# **28F008SA/SA-L SPECIFICATION UPDATE**

Release Date: February 1997

Order Number 297183-007

The 28F008SA/SA-L may contain design defects or errors known as errata. Characterized errata that may cause the 28F008SA/SA-Ls' behavior to deviate from published specifications are documented in this specification update.

**Erratum Identification/Resolution**

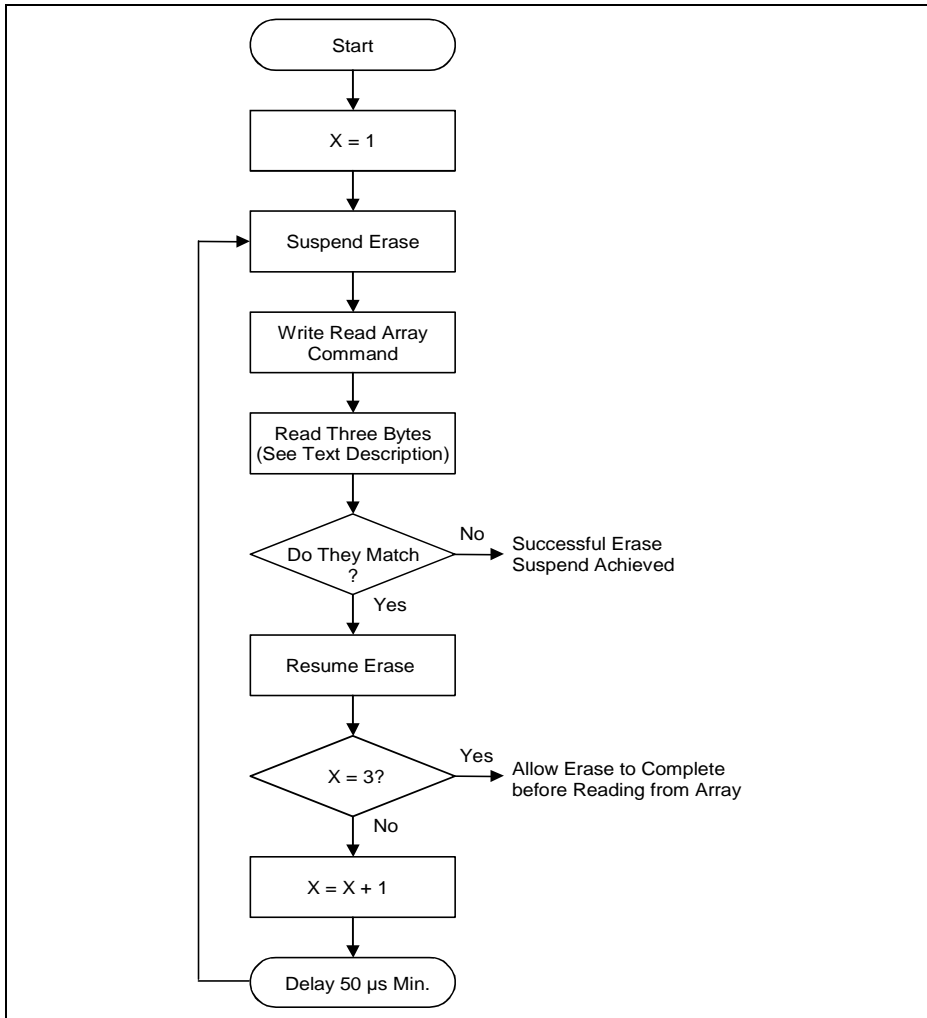
Affected components in erase suspend to array mode will occasionally, after the Read Array command is written to them, output invalid array data due to an error in the State Machine circuitry. The device in this instance enters an invalid erase suspend mode and outputs invalid data bytes. Statistically, this has occurred approximately once every 500 erase suspend attempts.

**WORKAROUND:** The following procedure will reliably and consistently alert system software that the 28F008SA/28F008SA-L has entered the invalid erase suspend mode. In almost all cases, this solution will also enable successful erase suspend. Reference the *Erratum Identification/Resolution* figure for a graphic description of the steps outlined below:

1. Write the Erase Suspend command to the device.
2. Poll the Status Register to determine when Erase Suspend has been achieved.
3. Write the Read Array Command to the device.

4. Read three bytes of data from a block **other than that being erased**.
  - At least one of the three bytes should have a **known different value** compared to the other two.

- Hold device addresses  $A_0$ – $A_1$  and  $A_{10}$ – $A_{19}$  constant through the three reads.
  - Toggle addresses  $A_2$ – $A_9$  to access different byte locations for the three reads.

5. **If the values at these three locations DO NOT match (as expected), you have successfully entered erase suspend to array mode.**
6. If the values at these three locations match, you have not successfully entered erase suspend to array mode on this attempt. Instead, you have entered the invalid erase suspend mode.

- Write the Erase Resume command to the device.
7. Read the device outputs (poll the Status Register) to determine when erase resumption has been achieved.

8. Wait 50  $\mu$ s.
9. Re-execute the erase suspend attempt up to two more times (or three times total).
10. If not successful after three attempts, issue the Erase Resume command, and allow the internal erase algorithm to complete before attempting to read from the array.

### Alternate Identification/Resolution

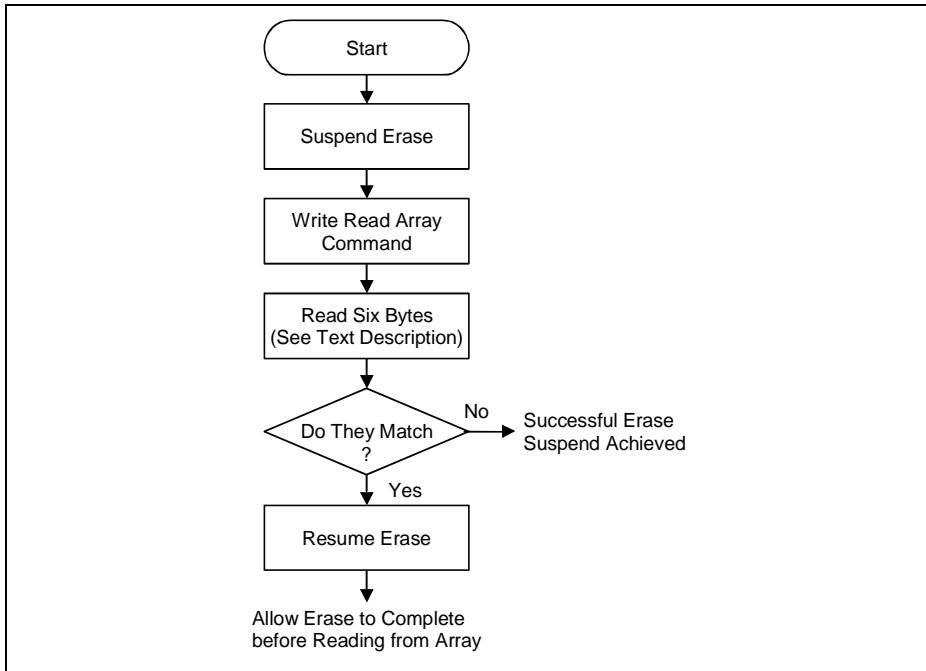
The following procedure will also reliably and consistently alert system software that the 28F008SA/28F008SA-L has entered the invalid erase suspend mode. This procedure should be used if the system cannot identify unique bytes on the component within a 256-byte “window” defined by  $A_2$ – $A_9$ . This approach is easier to implement, but may cancel erase suspends that have correctly executed, since it examines undefined data. Reference the *Alternate Identification/Resolution* figure, which follows, for a graphic description of the steps outlined below:

1. Write the Erase Suspend command to the device.
2. Poll the Status Register to determine when Erase Suspend has been achieved.
3. Write the Read Array Command to the device.
4. Read six bytes of data from a block **other than that being erased**.
  - Hold device addresses  $A_0$ – $A_1$  and  $A_{10}$ – $A_{19}$  constant through the six reads.
  - Toggle addresses  $A_2$ – $A_9$  to access different byte locations for the six reads.
5. **If the values at these six locations DO NOT match, you have successfully entered erase suspend to array mode.**
6. If the values at these six locations match, write the Erase Resume command to the device, read the device outputs (poll the Status Register) to determine when erase resumption has been achieved, and allow the internal erase algorithm to complete before attempting to read from the array.

**AC Waveform for Reset Operation**

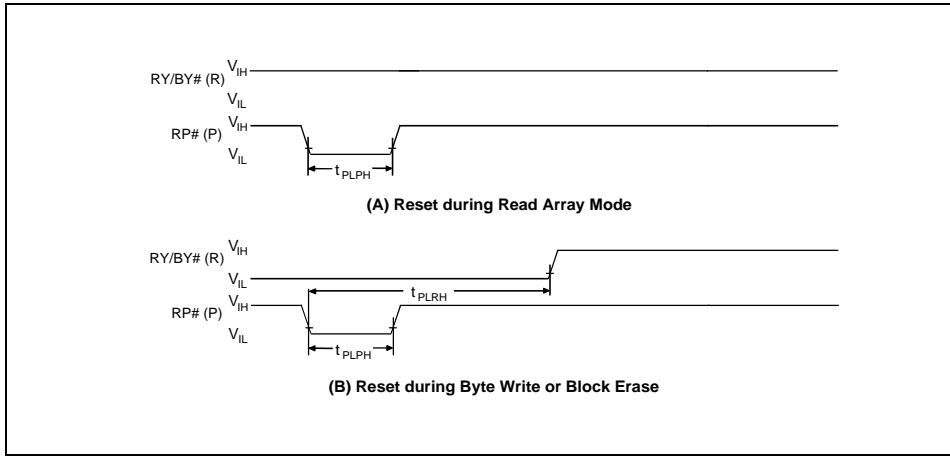
**PROBLEM:** Two reset specifications have been added to the 28F008SA. Please add this information the existing datasheet. The next datasheet revision will incorporate these reset specifications.

Sym	Parameter	Notes	V <sub>CC</sub> = 5V		Unit
			Min	Max	
$t_{PLPH}$	RP# Pulse Low Time (If RP# is tied to V <sub>CC</sub> , this specification is not applicable)		100		ns
$t_{PLRH}$	RP# Low to Reset during Block Erase or Byte Write (If RP# is tied to V <sub>CC</sub> , this specification is not applicable)	2,3		12	μs

1. These specifications are valid for all product versions (packages and speeds).
2. If RP# is asserted while a block erase or byte write operation is not executing, the reset will complete within 100 ns.
3. A reset time,  $t_{PHQV}$ , is required from the latter of RY/BY# or RP# going high until outputs are valid.

In read modes, RP#-low deselects the memory, places output drivers in a high-impedance state and turns off all internal circuits. RP# must be held low for a minimum of 100 ns. Time  $t_{PHQV}$  is required after return from power-down until initial memory access outputs are valid. After this wake-up interval, normal operation is restored. The CUI is reset to read array mode and status register is set to 80H.

During block erase or byte write, RP#-low will abort the operation. RY/BY# remains low until the reset operation is complete. Memory contents being altered are no longer valid; the data may be partially erased or written.
